S E R V I C E N O T E

6015A Autoranging DC Power Supply

Prevent Spurious High Frequency Down Programmer FET Oscillations

FIGURE 1

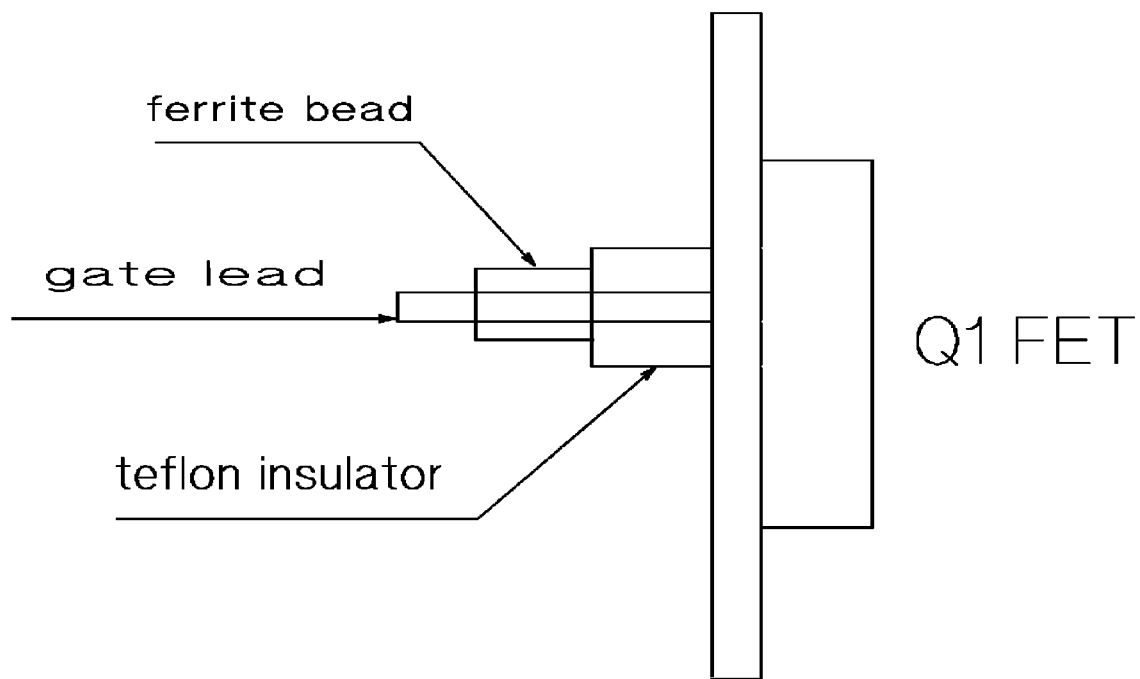
The downprogrammer power FET A5Q1 may exhibit spurious high frequency oscillations when the power supply output voltage is decreased at a slow slew rate.

Add magnetic shield bead, part number 9170-0894, to the gate lead of A5Q1 power FET. The magnetic bead should be inserted on the gate lead after inserting the teflon insulator. See figure 1.
